Aug 23, 2021

Re: 2025 St. Johns St. – Response to Council 1st Reading Comments

Figure 1 - RTA Variance

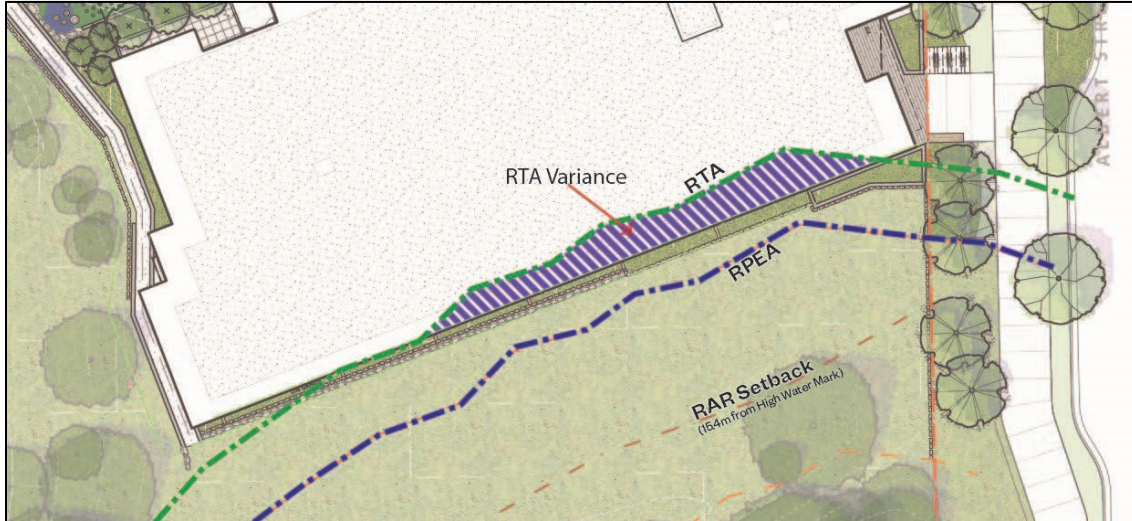
It should be noted that the project meets and exceeds the 15m Riparian Protection Enhancement Areas (RPEA) setback. However, the site requires an approximate 3m variance to a segment of

the Riparian Transition Area (RTA) line where a ‘peaked’ section of the line overlaps the parkade – see Figure 1.

As compensation for the variance, we will be providing off-site riparian restoration and removal of invasive species for the ravine located to the south of the site and representing an area of over 1700m².

Figure 3 - Impact of Full RTA Setback – P1 & P2

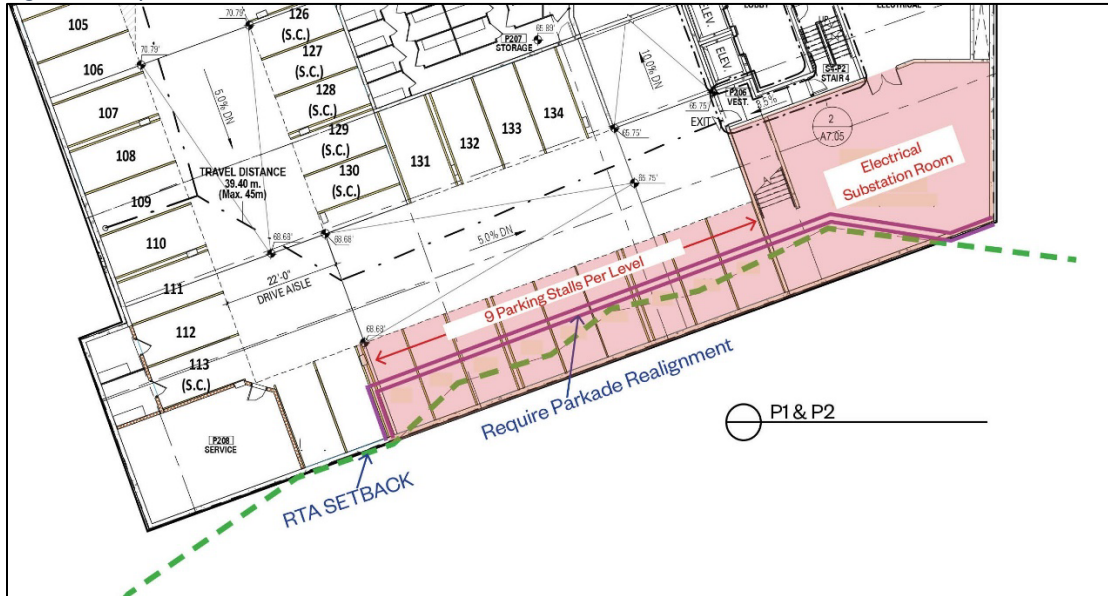
The configuration of the RTA is such that a small triangular section overlaps with the southern edge of the parkade design. As illustrated in Figures 2 to 4, adjusting the parkade to accommodate the full 5m RTA setback would result in the following impacts to the parkade and other key functions of the building:

- Parking – 27 parking stalls, 9 on each of the three levels, would be affected and need to be relocated, requiring additional levels of the parkade to be added.

- Bicycle Facilities – The current building is well-suited to bicycles as it provides direct access to the main bike lockers, repair room and bike wash station. Accommodating the full setback would eliminate this bicycle-friendly access and require it to come from the parkade. In addition, the number of bike lockers would also be impacted requiring these be relocated to lower levels of the parkade.

- Electrical Substation Room – BC Hydro stipulates minimum equipment clearances within substation rooms. With this space reduction, a new location for the room would need to be determined which would displace more parking, storage, and bike facilities. These facilities would need to be relocated lower in the parkade and likely increasing the depth to the excavation.

- Building 2 Lobby – Due to the sloping nature of the site, there is a grade difference between the street and the lobby, and between the lobby and the first level of the building. The additional space constraints make meeting the wheelchair accessibility requirement of the lobby, as well as the exiting requirements, of this building extremely difficult. This would likely result in unconventional building entry and circuitous routing for accessible access.

The result of this inefficiency means the parkade would need to be extended down to at least a fourth, if not a partial fifth, level. Construction costs aside, there is an environmental cost associated with all the extra excavation, structural concrete and steel. Furthermore, the added cost undermines the project’s ability to provide other amenities such as, public art and affordable housing.

Figure 5 - Building 1 Rooftop Amenity

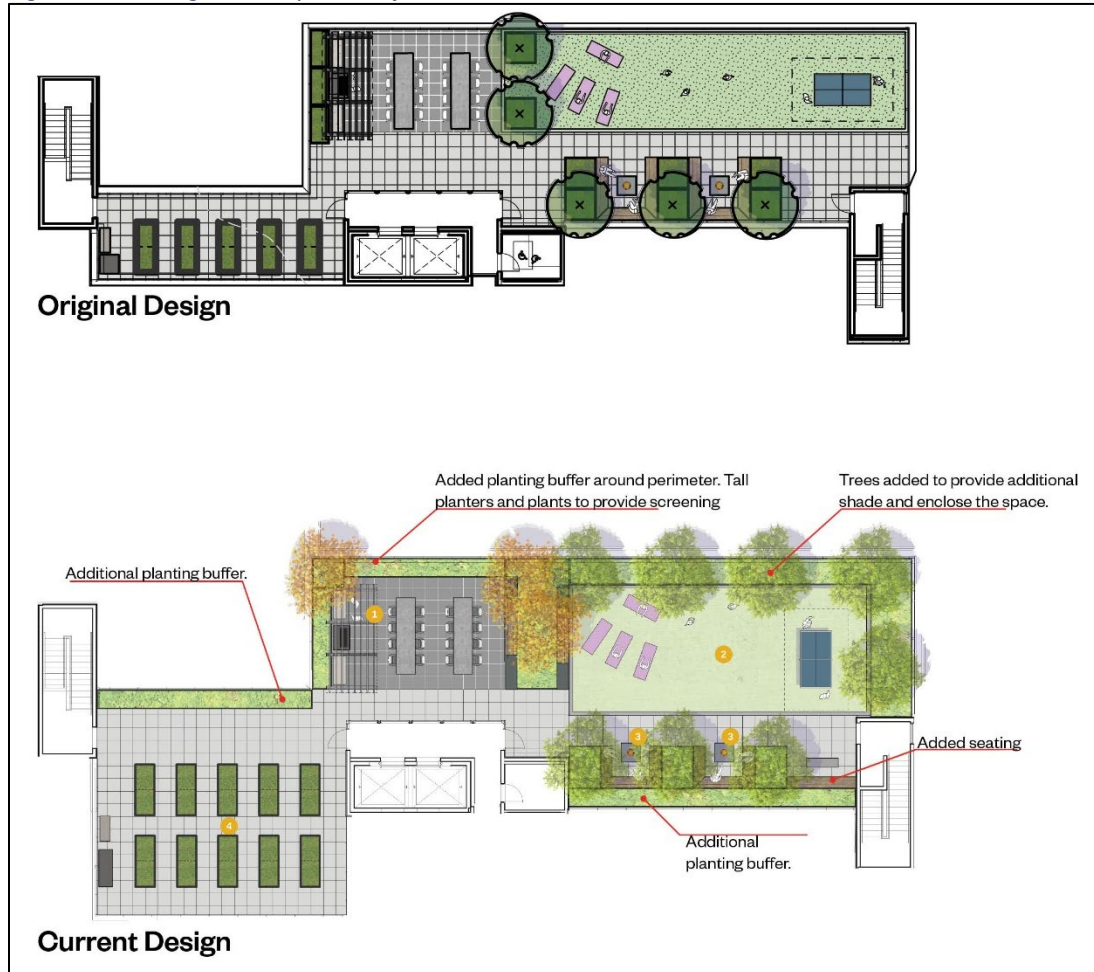
In addition to the items requested in Council's motion, we have provided further refinement and expansion to the rooftop amenity areas. As illustrated in Figures 5 and 6, additional planters and extensive planting has been added throughout the rooftop provide a more natural and inviting setting. The number of trees has been increased to provide for more natural shading and to help reduce 'heat island' effect. The intent of the changes was to sense that the area is a lush garden space while also affording people views of the water and mountains.

The overall rooftop amenity space has been increased by 20% to not only provide for improved programming and landscaping, but also to provide better separation of activities. The urban agriculture components are separated from the outdoor dining and recreation areas to allow each to operate more freely and without potential conflict.
